SCHOLES INTERNATIONAL AIRPORT (GLS)
GALVESTON, TEXAS

TxDOT CSJ No.: 2512GLVST

ADDENDUM NO. 1

May 1, 2025

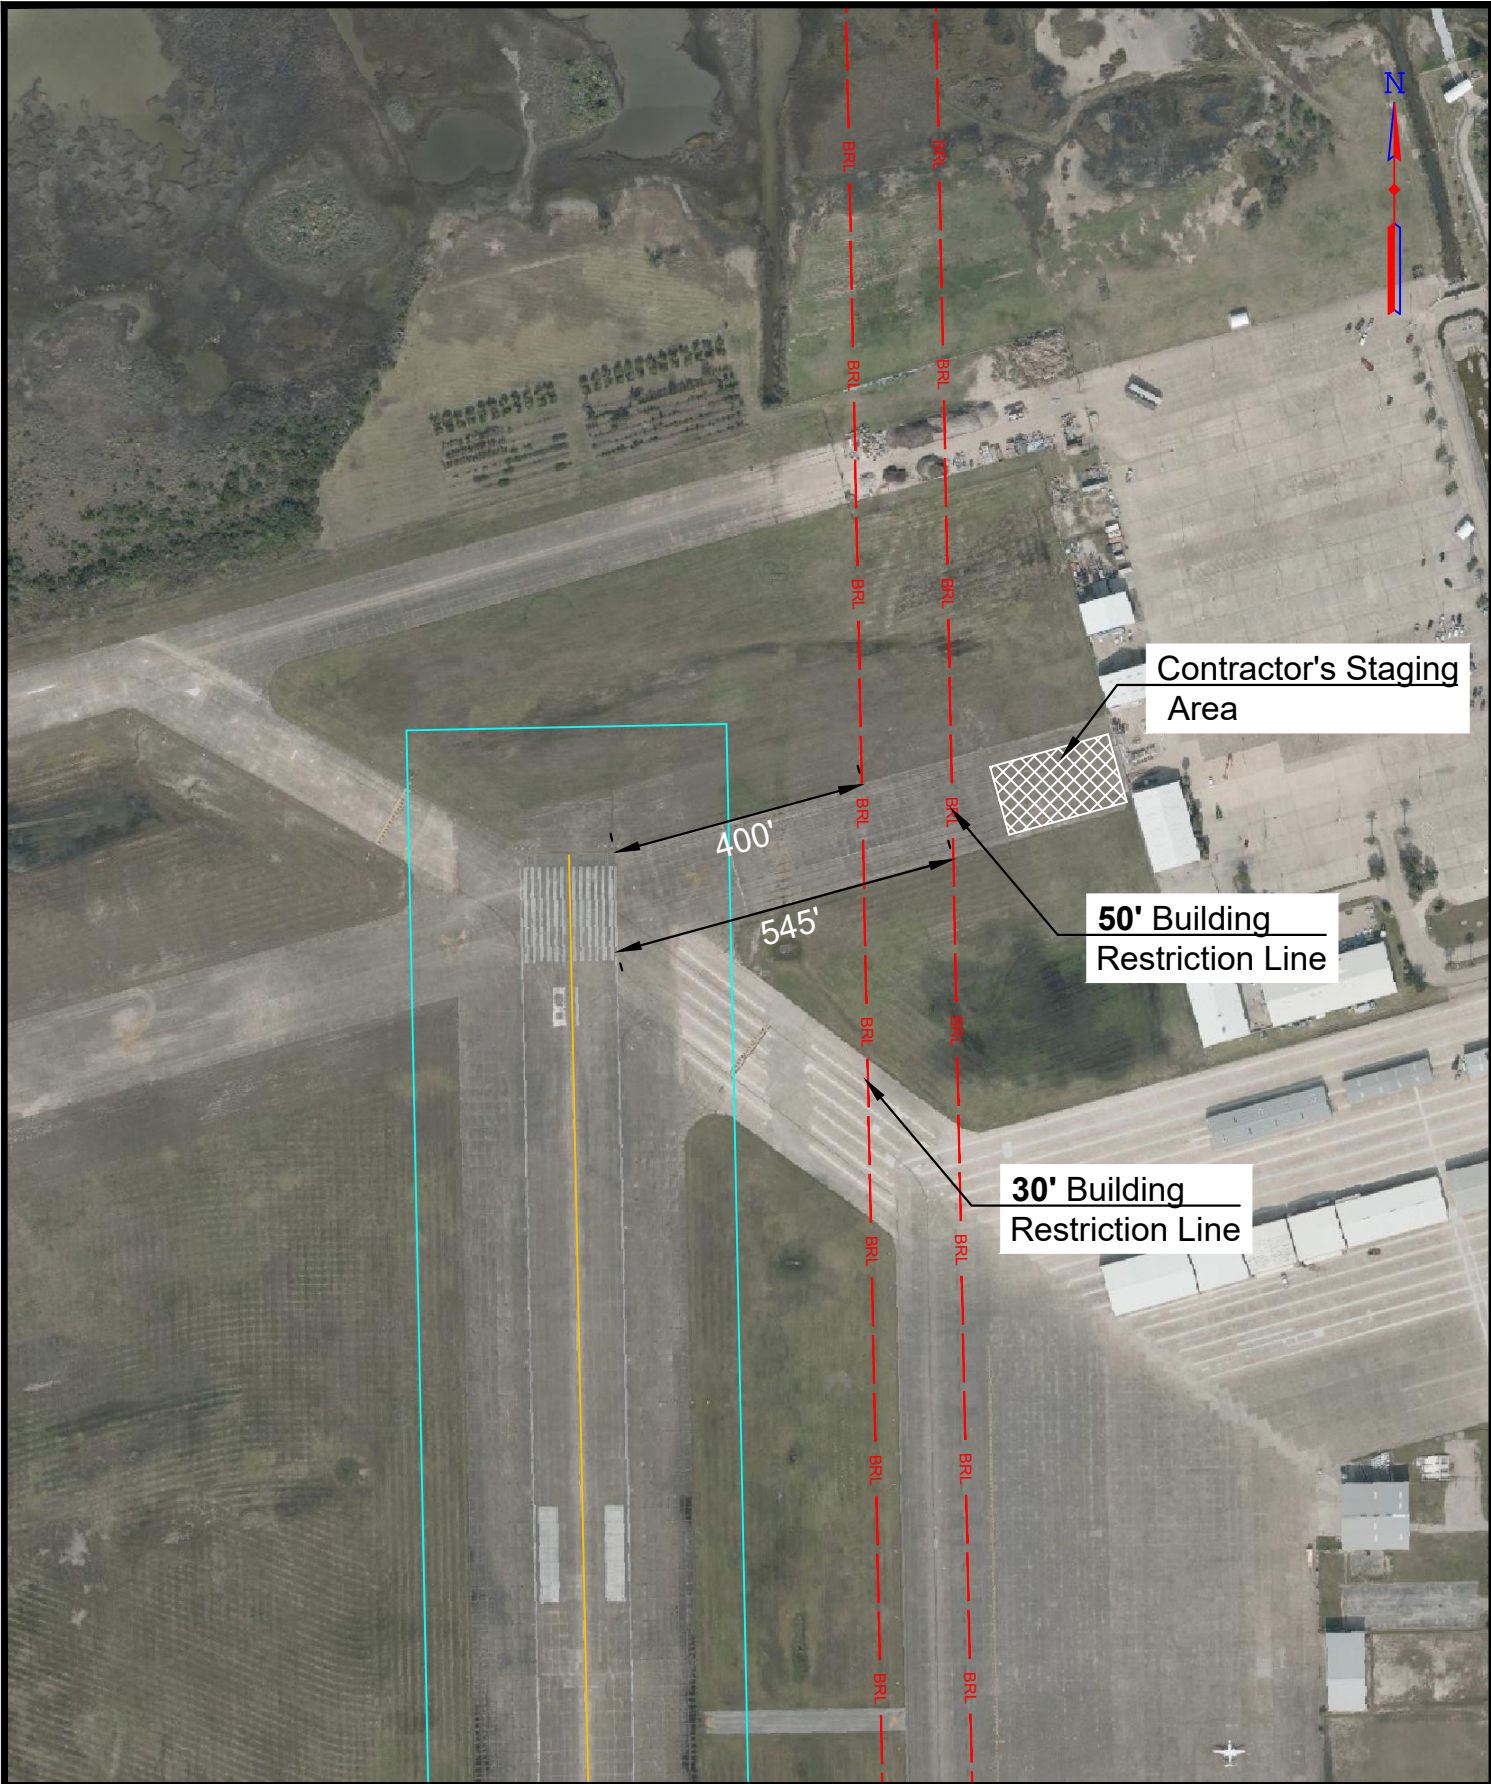
The Bid Form posted online will be revised to correct calendar days. Additionally, see attached Gantt chart for clarification.
5. Do you have pictures of the existing grate inlets as we weren't able to see all of them today due to the rain?
 - a. Answer:

Photos are included after contractor questions and answers. Photos were taken of existing inlets in January 2025 and can be provided to the contractor. These photos may not represent the current conditions. The airport can provide access to the site upon request by the contractor to verify existing conditions.

SCALE: 1" = 300'

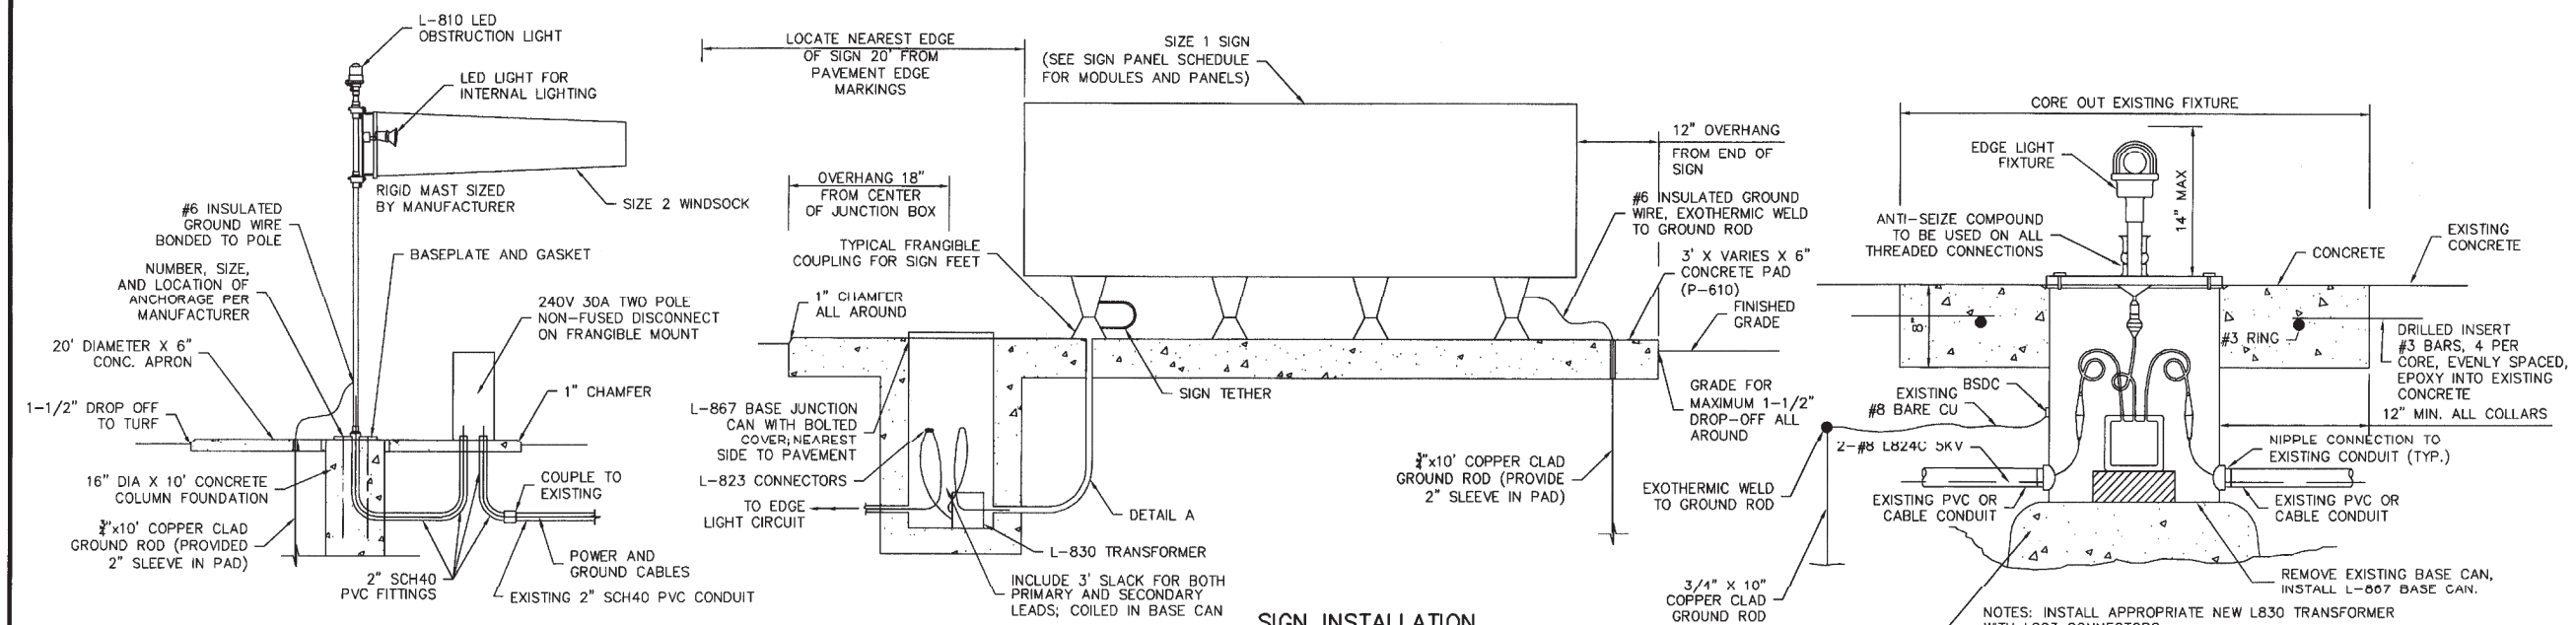
2. Can the contractor place a 37' concrete batch plant in the northeast corner of the airport property adjacent to the staging area?
 - a. Answer:
 - i. See attached figure for batch plant location Building Restriction Line (BRL) limit so as not to penetrate airspace surfaces.
 - ii. The successful contractor shall complete *Form FAA 7460-1 Notice of Proposed Construction or Alteration* and receive approval from FAA prior to constructing a batch plant for this project. If contractor elects to build the batch plant prior to FAA approval, it shall be done at their own risk.
3. Are there any electrical foundation details for the sign bases?
 - a. Answer:

2512GLVST CONTRACT TIME

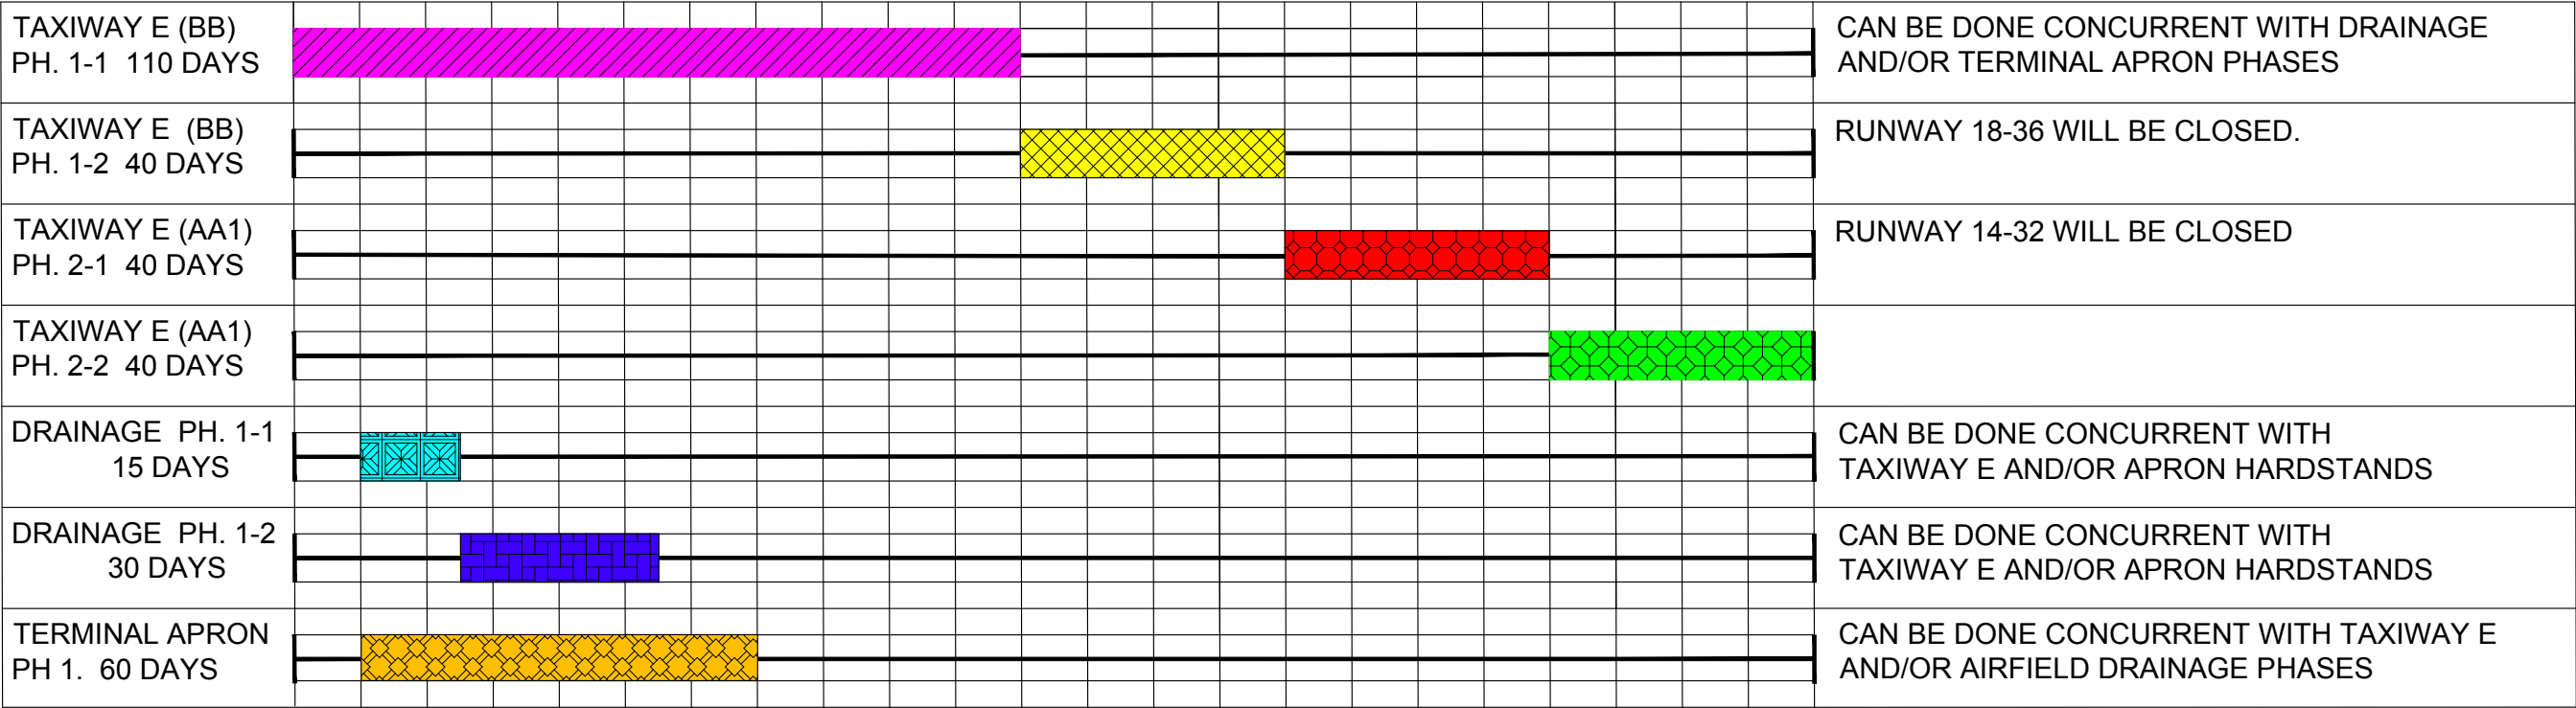
6. Can you please provide a preliminary construction schedule?
 - a. Answer:

The CSPP provides the estimated Calendar Days for each Task – Taxiway E, Drainage, Apron Hardstands. An updated Gantt chart is included to provide further clarification.
